# Balboa Avenue Station Area Specific Plan

## Program Environmental Impact Report

### Comment Letters and Responses

## Summary of Comments on Connect PB Comments.pdf

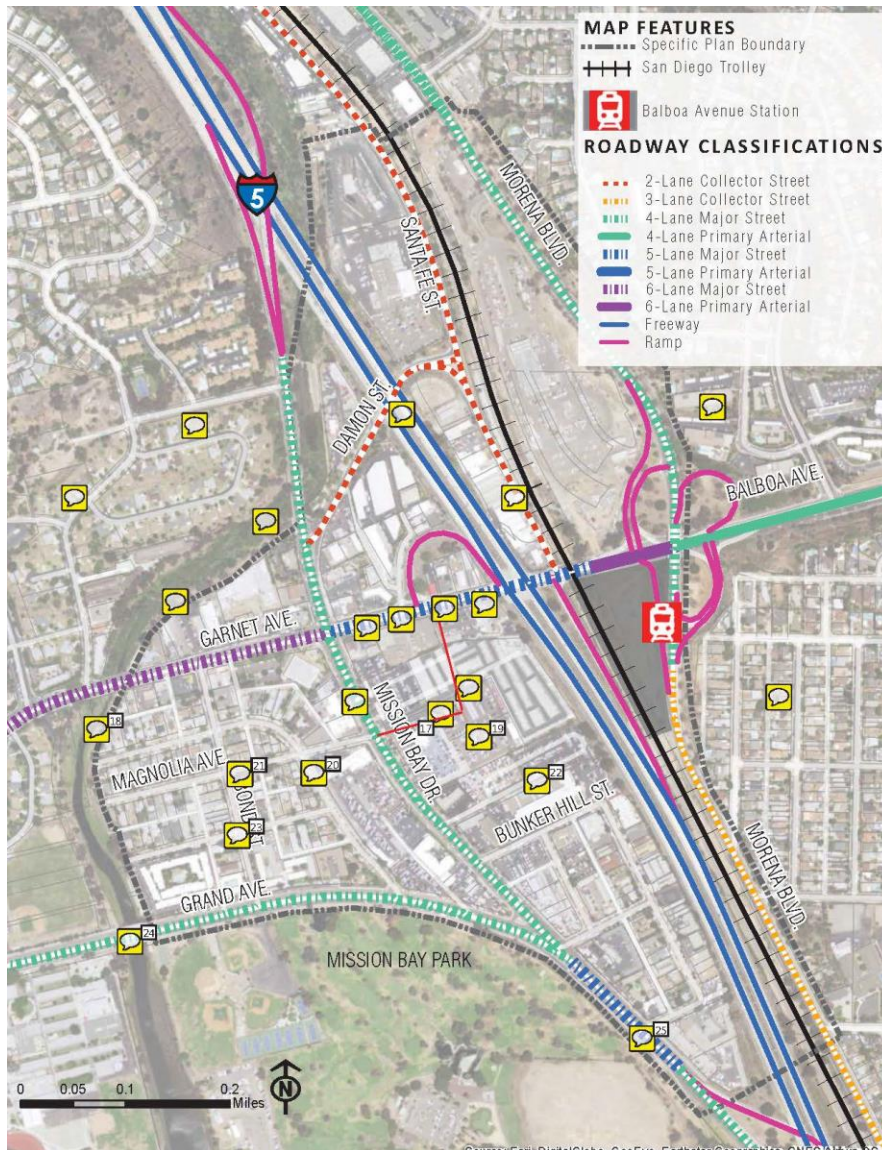
Number: 1	Author: 30054	Subject: Sticky Note	Date: 6/12/2018 6:41:20 AM
Maintain and enhance multifamily zoning.			
Number: 2	Author: 30054	Subject: Sticky Note	Date: 6/12/2018 6:45:24 AM
Pedestrian Crossing			
Number: 3	Author: 30054	Subject: Sticky Note	Date: 6/12/2018 6:50:25 AM
General housing comments:			
*middle income not enough housing			
*designating low income one area needs to change			
*pushing low income segregation			
*maintain multi-residential, not fill with luxury homes			
*diversity in community can be achieved by different types of affordable housing			
*balancing with open environment			
*design guidelines can be created based on eco-principles			
Number: 4	Author: 30054	Subject: Sticky Note	Date: 6/12/2018 7:06:00 AM
General Mobility comments:			
*Shuttle system (frequent, private sector?)			
*Better facility around Rose Creek (cultural trail)			
*Fear of additional lanes on Garnet/Balboa

*Better N-S & E-W connection			
*Resurface/Repurpose per Bike Master Plan			
*CIP solutions - Bridge, Tunnels, Skyfari			
*Neighborhood pathway from Balboa transit through development to Magnolia Ave.			
*Electric vehicle / Private Sector shuttle, PB, LI, MB, i.e. Sunrunner, 1st phase, fun & unique			
*Better bike facility along rose creek			
*Support the bike share program in PB			
*Highlight benefits of bike riding and enhance safety			
Number: 5	Author: 30054	Subject: Sticky Note	Date: 6/12/2018 7:00:27 AM
Santa Fe is an incline			
Number: 6	Author: 30054	Subject: Sticky Note	Date: 6/12/2018 6:47:41 AM
Rose Creek - Proposed Designated Parkway			
Number: 7	Author: 30054	Subject: Sticky Note	Date: 6/12/2018 6:31:33 AM
Several comments were provided related to the environment and Rose Creek:
